ACCESSIBILITY ASSESSMENT REPORT

Clearwater Public Library

Clearwater Public Library

RHFAC v4.0 RATING SURVEY

WHOLE FLOOR

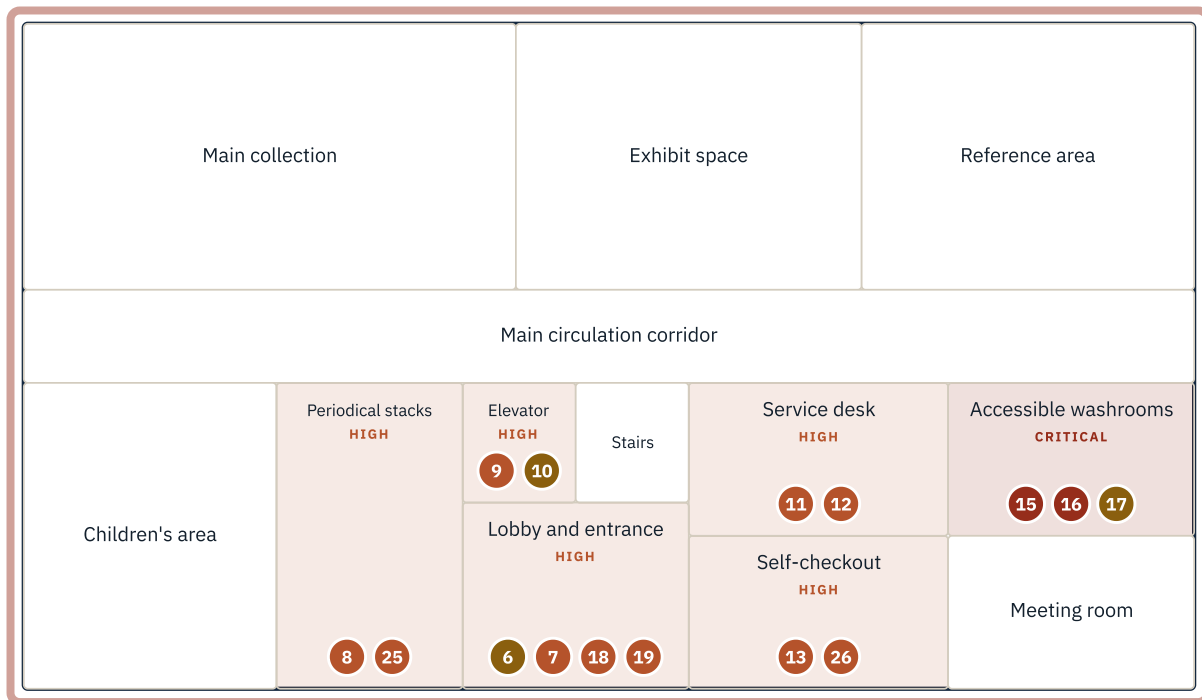
Finding 23 — no visual fire alarm coverage on the main floor. A whole-floor failure, so it carries no single pin. Costed once, with the upper floor, at \$8,500–\$14,000.
